Proposed Glades restaurant extension on Queens Garden - Joint Report by

The Friends of Bromley Town Parks & Gardens & Bromley Civic Society - November 2011

Solid Line - the currently proposed development site.

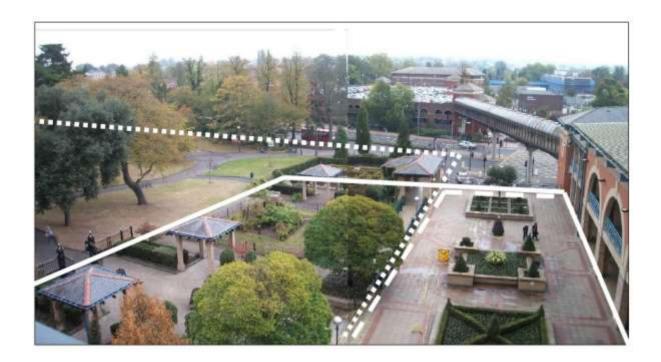
- 1. The new development site (solid black line) is <u>not</u> that shown on the AAP map (dotted black line) <u>nor</u> one ever submitted to any AAP consultation or discussion with the AAP Inspector.
- 2. The new development site is on landscaped green space yet AAP Policy OSM states that "New cafes and restaurants will be permitted around the edge of the Garden provided that the development does not result in the loss of green space".

Half the development is within the Conservation Area boundary :

- The statutory requirement is for the character or appearance of a conservation area to <u>be</u> <u>preserved or enhanced</u>. The CA will neither be preserved or enhanced as the landscaped open space would be lost as would its contribution to the open character of the wider Garden and conservation area which will be encroached upon by commercial buildings.
- 3. Council policy BE13 is to oppose development which would <u>harm views into or out of a</u> <u>conservation area</u>. The <u>view out</u> of the Conservation Area across the Glades Terrace (also proposed for development) and the contribution it makes to the open space would be not only harmed but lost altogether. Similarly the <u>view into</u> the CA from the Terrace and the upper walkway of the Pavilion would be lost.
